**HONG KONG**  
**FIRE SERVICES DEPARTMENT**

**TECHNICAL GUIDANCE**

**Application of Loss Prevention Council Rules**

**for Automatic Sprinkler Installations 2015**

Figure 10 (Revised) – Distance of sprinkler deflector from beams

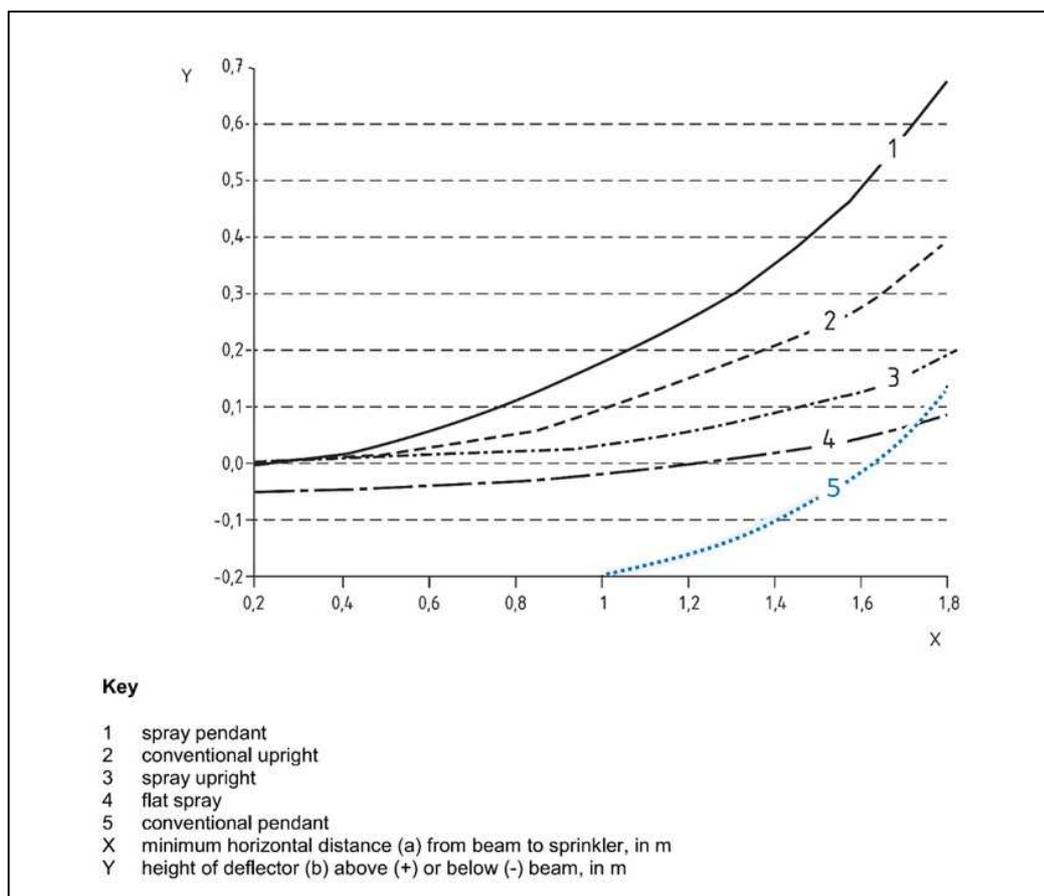
✎ **Figure 10 of Clause 12.4.6** should be revised as follows

Figure E.2.4 (a) Distribution pipework friction loss calculation

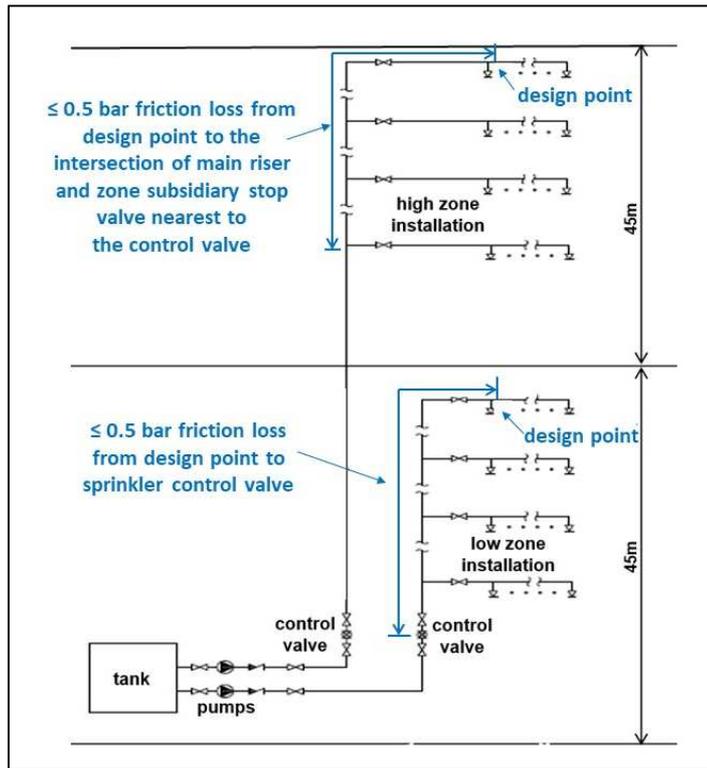
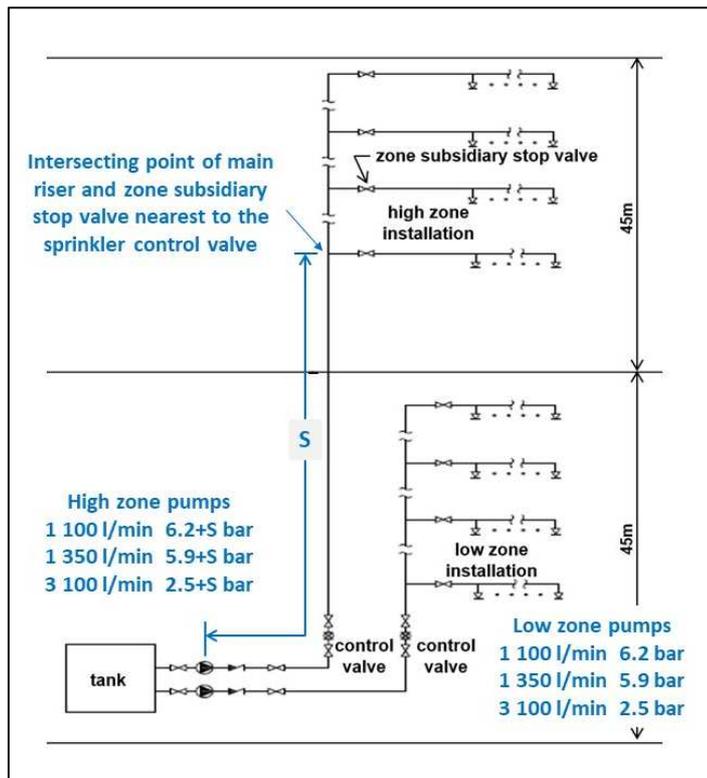
✎ **Clause E.2.4** should be revised and read as

might be increased by an amount equal to the difference in static head gain between the sprinklers at the level concerned and the highest sprinkler in the installation.”

Note: This is to in line with TB210.7.1 and Table TB210.T5.

**Figure TB210.F6 (Revised) Typical pump priming arrangement for suction lift**

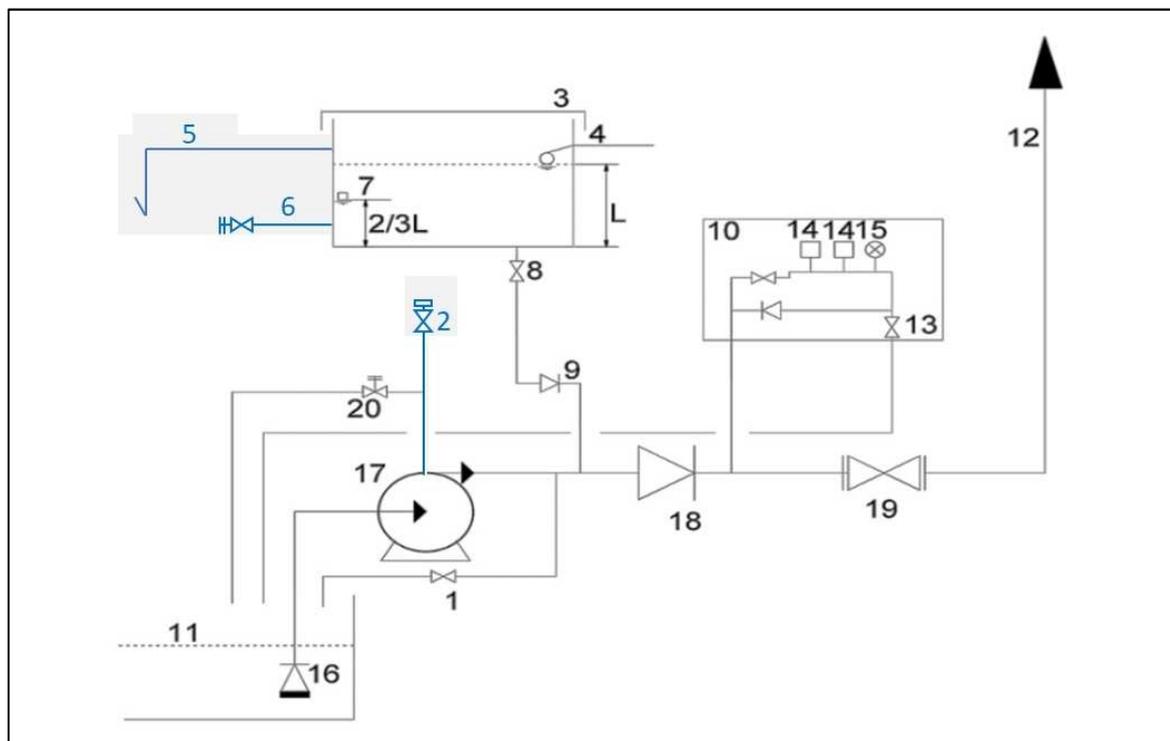
- ✎ **Figure TB210.F6** should be revised and read as

Note: This is to meet WSD's requirements.

**Figure TB210.F7 (Revised) Typical pump priming arrangement for suction lift**

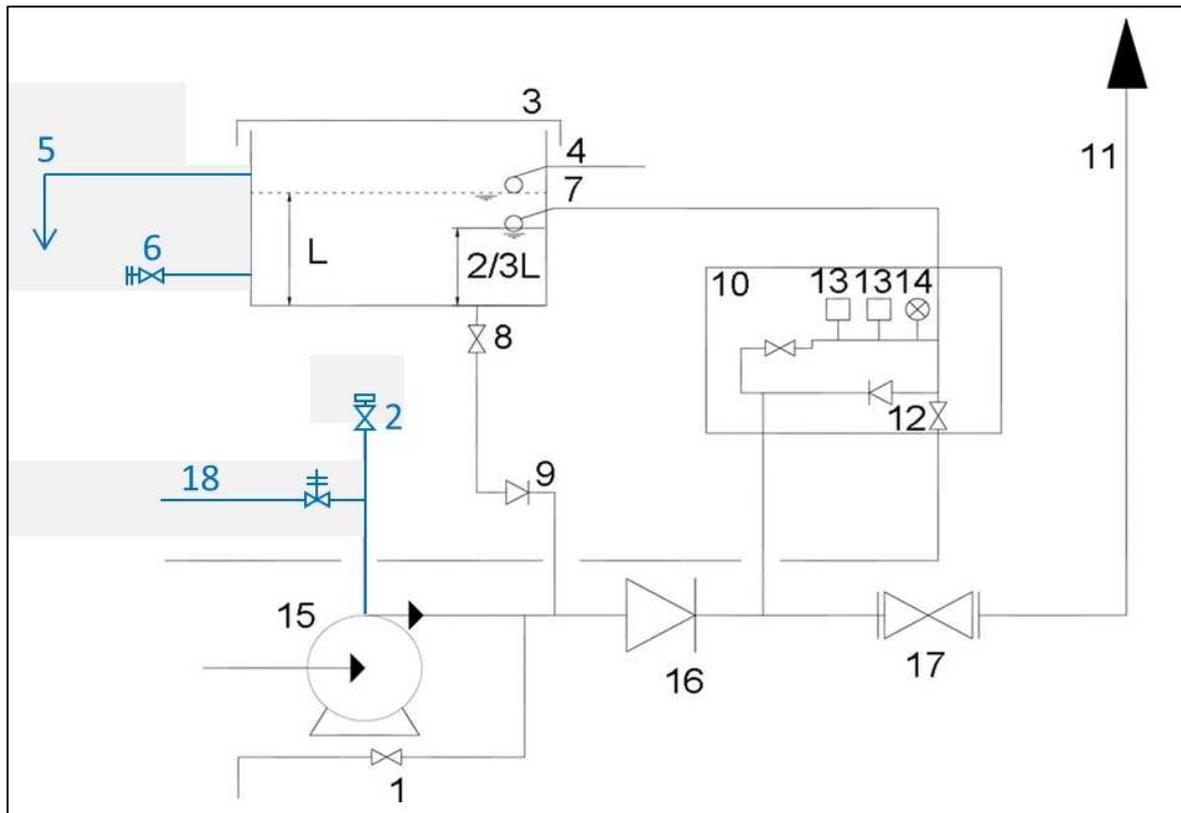
**Figure TB210.F7** should be revised and read as

**Figure TB210.F11 (Revised) Typical jockey pump arrangement for pumps operating under positive suction head**

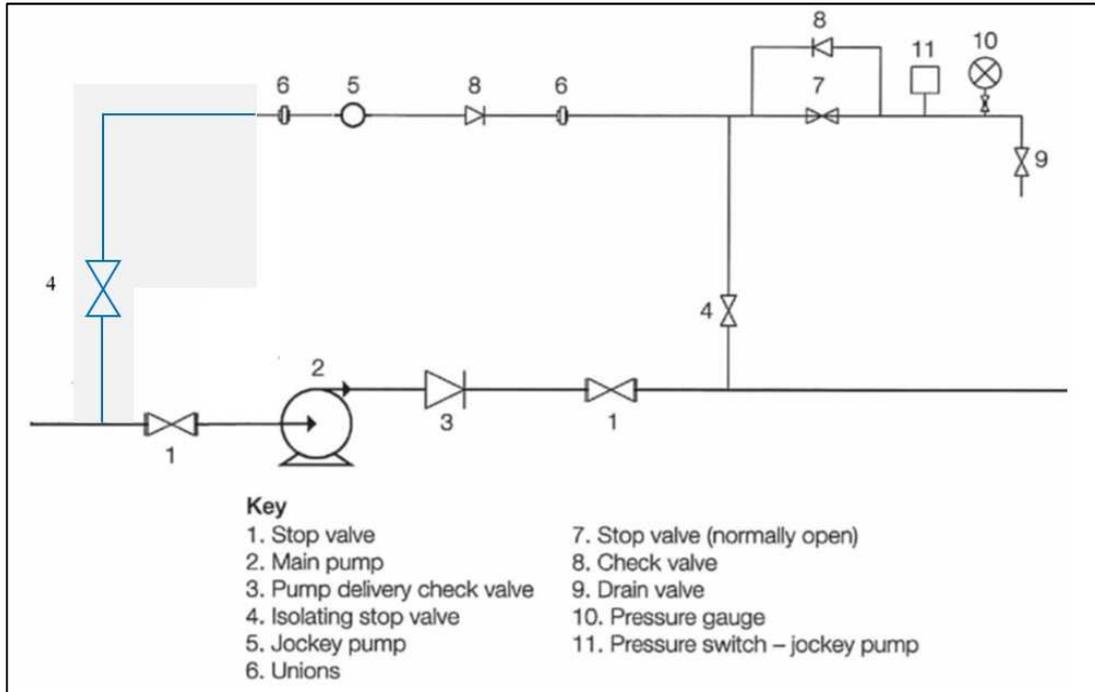
✎ **Figure TB210.F11** should be revised and read as

Note: This is to avoid interruption to the jockey pump operation when the sprinkler pump is isolated for whatever reason.

**Figure TB218.F2 (Revised) Superior single water supply using suction pump**

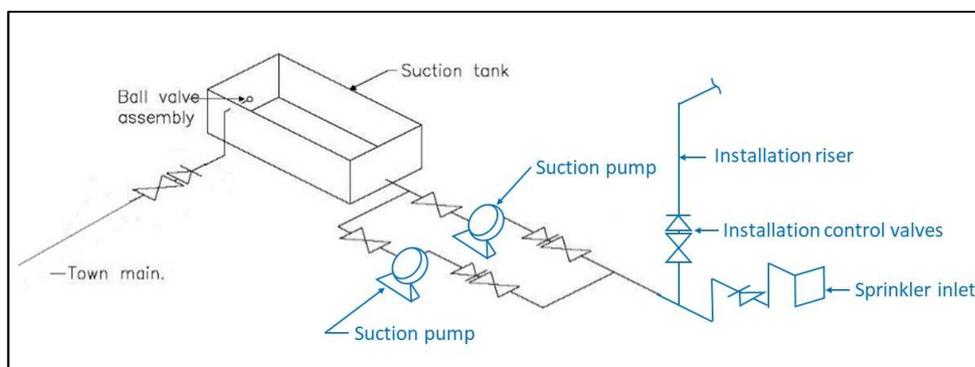
**The** **Figure TB218.F2** should be revised and read as

Note: To suit local practice, some descriptions of the diagram were revised as below:

**Figure TB218.F6 (Revised) Duplicate supplies using two suction pumps from a limited capacity tank and full capacity tank**

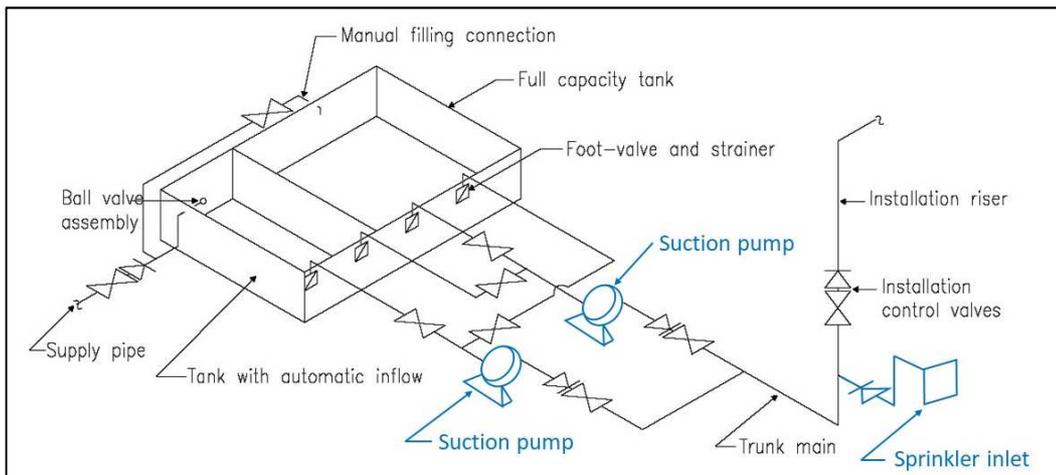
**R** **Figure TB218.F6 should be revised and read as**

Note: To suit local practice, some descriptions of the diagram were revised as below:
